ADDENDUM NO. 1

April 3, 2024

107 JESSUP ROAD
ITHACA, NEW YORK 14850

CHILD CARE CENTER SWING SPACE AT RPCC

2 WALL SECTION AT PENTHOUSE WALL INFILL SCALE: 3/4" = 1'-0"

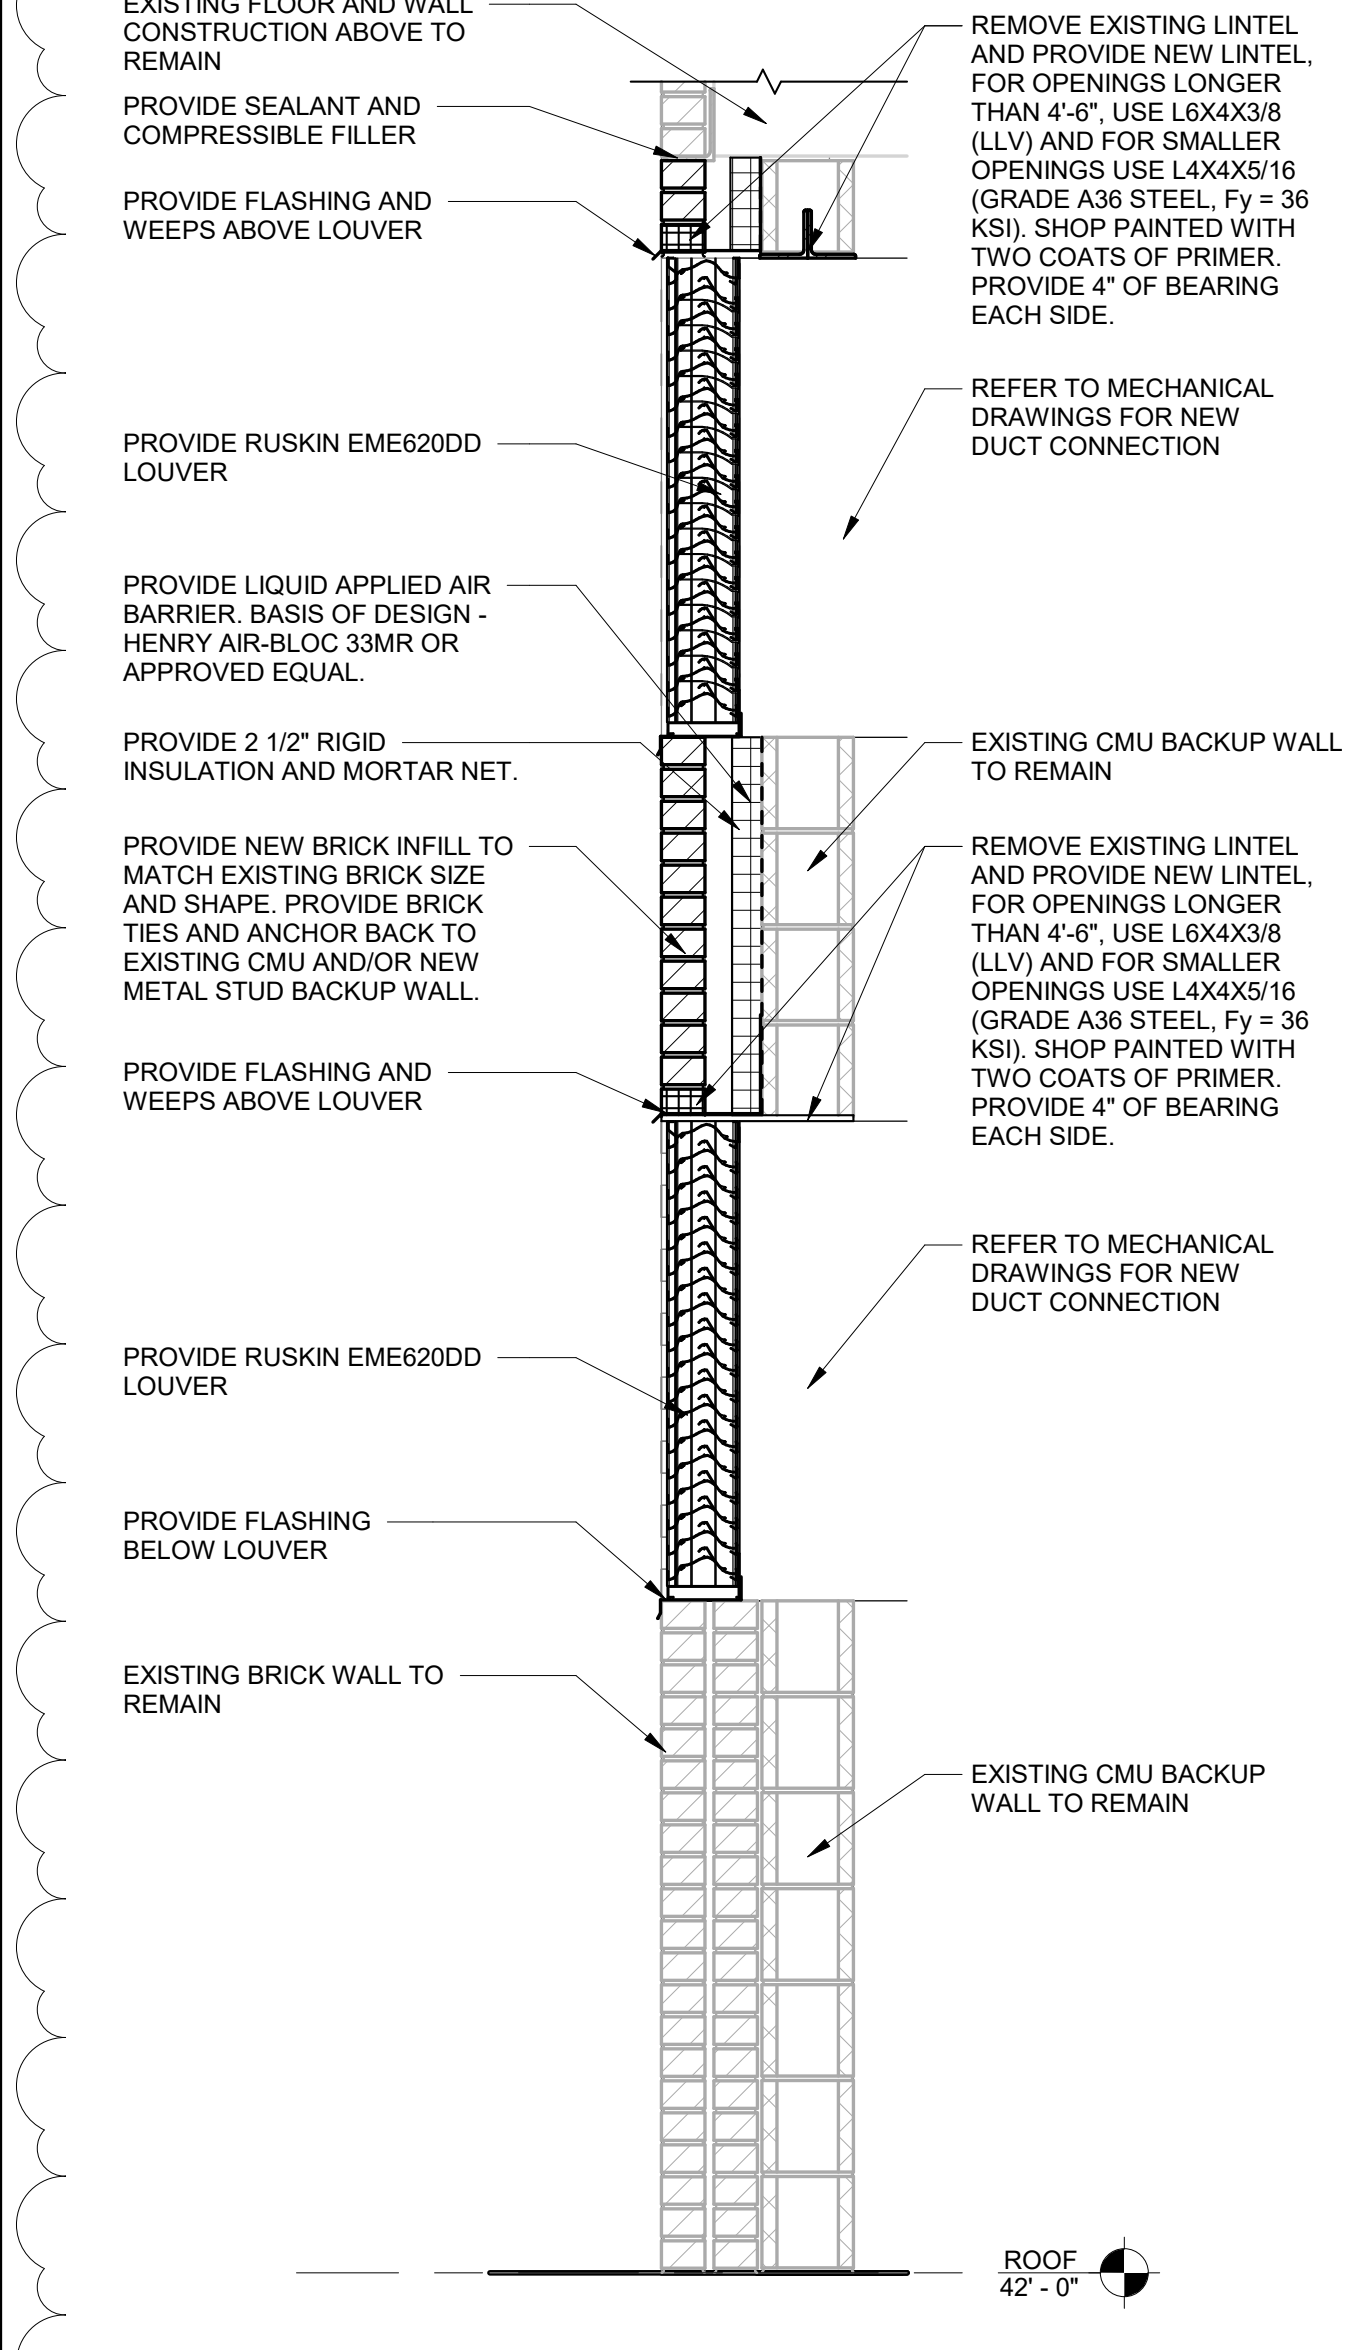
1	PROVIDE BRICK INFILL. REFER TO WALL SECTIONS ON A-001R FOR MORE INFORMATION.
2	PROVIDE METAL STUD INFILL AT CMU BACKUP WHERE EXISTING LOUVERS WERE REMOVED. REFER TO WALL SECTIONS ON A-001R FOR MORE INFORMATION.
3	PROVIDE NEW LOUVER. REFER TO WALL SECTIONS ON A-001R FOR MORE INFORMATION.

1 PENTHOUSE WEST ELEVATION - DEMO
SCALE: 1/8" = 1'-0"

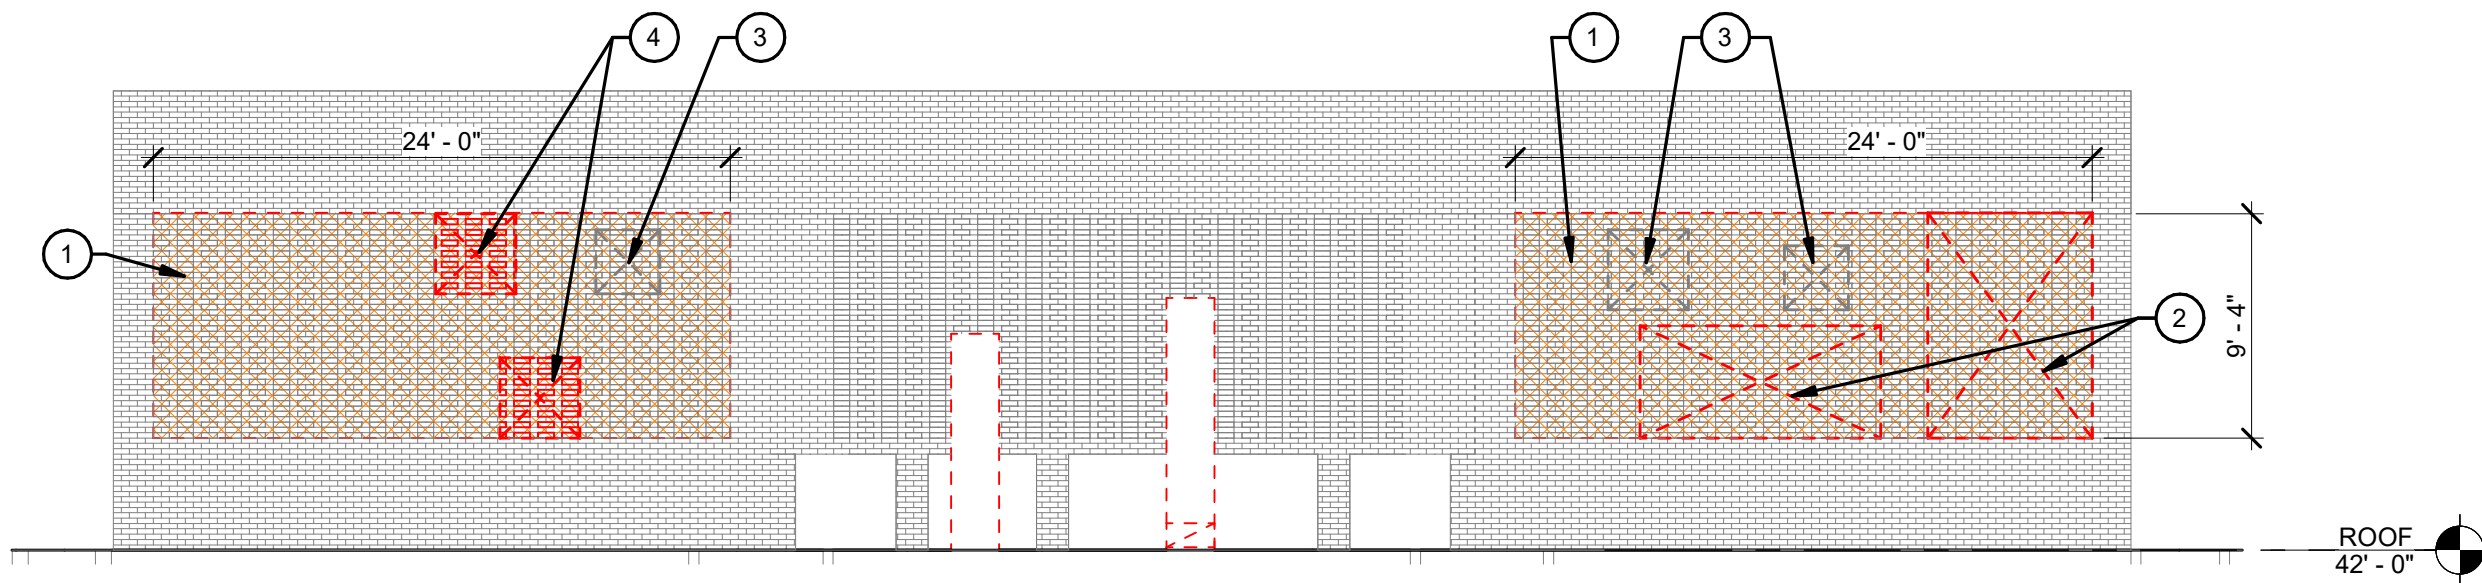
Item 6. Drawing A-102 – Demolition Plans, Detail 4 - Penthouse West Elevation, Demolition

DELETE detail 4 in its entirety.

REPLACE with revised Detail Sketch ADD1-A1 - Penthouse West Elevation - Demo, attached.

1	REMOVE EXISTING BRICKS IN THE HATCHED AREA. PREP AREA FOR WALL INFILL.
2	REMOVE EXISTING LOUVER. PREP AREA FOR METAL STUD INFILL.
3	PREP AREA FOR METAL STUD INFILL WHERE EXISTING LOUVERS WERE PREVIOUSLY REMOVED IN ANOTHER PROJECT.
4	REMOVE EXISTING LOUVER. PREP AREA FOR NEW LOUVER.

3 PENTHOUSE WEST ELEVATION - RENO
SCALE: 1/8" = 1'-0"

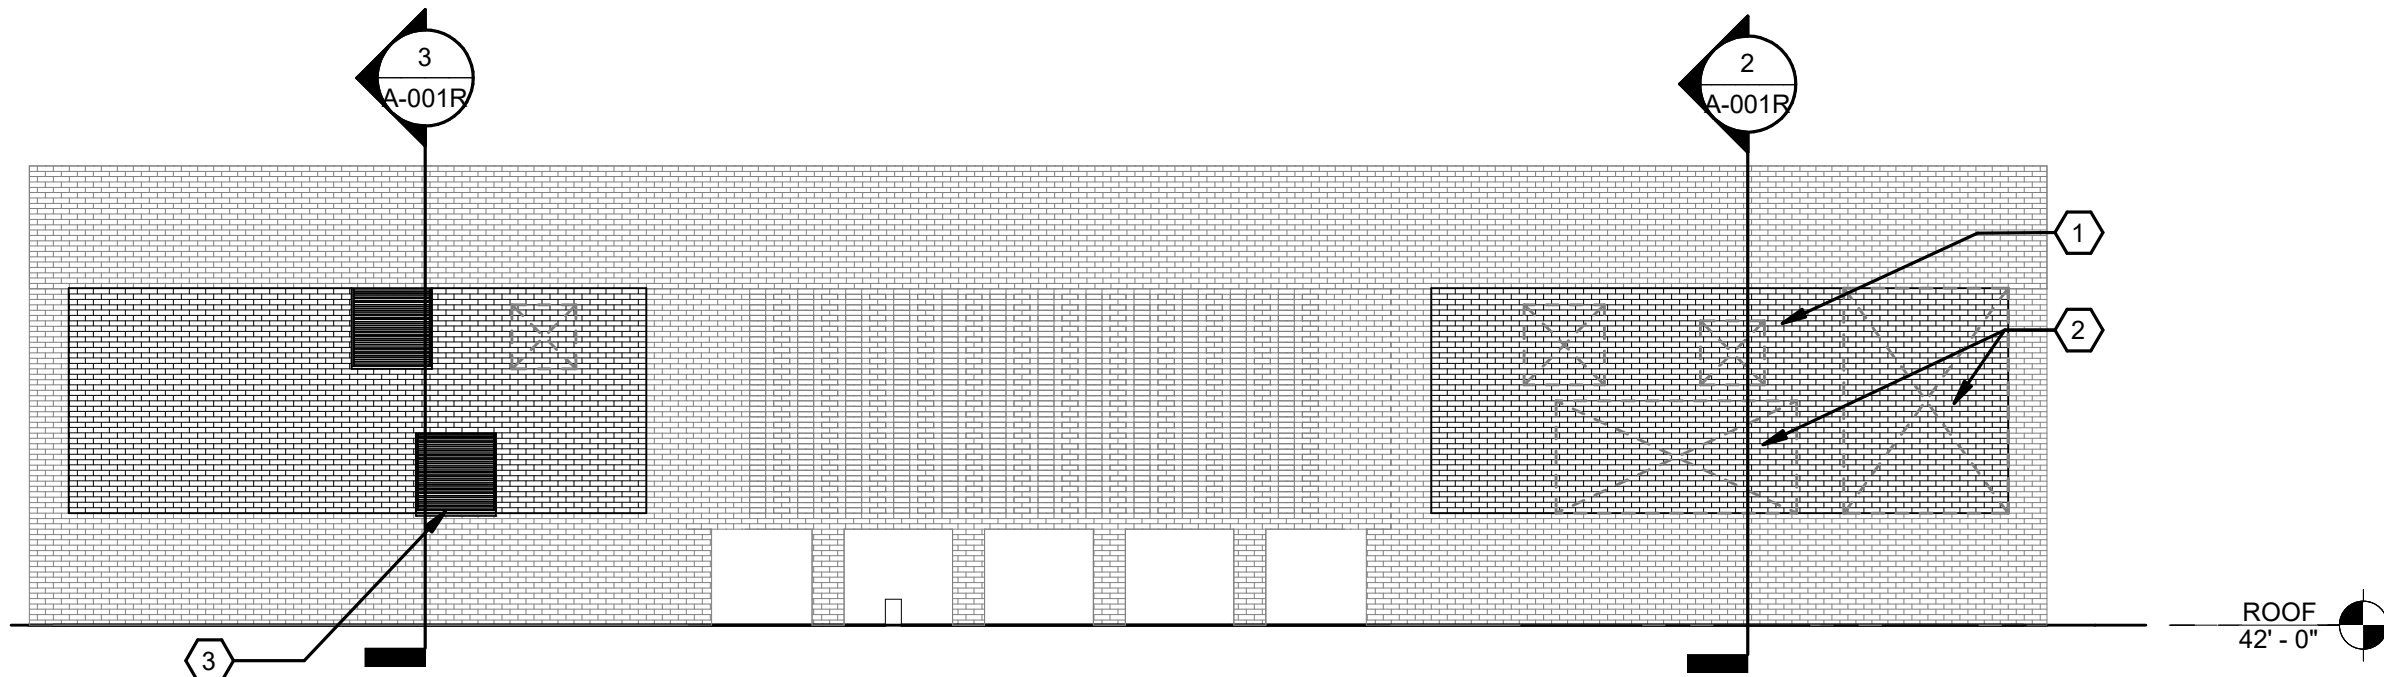
Item 11. Drawing A-104 – Third Floor Plan - North

ADD Sketch ADD1-A2, attached, as detail 3 to this drawing.
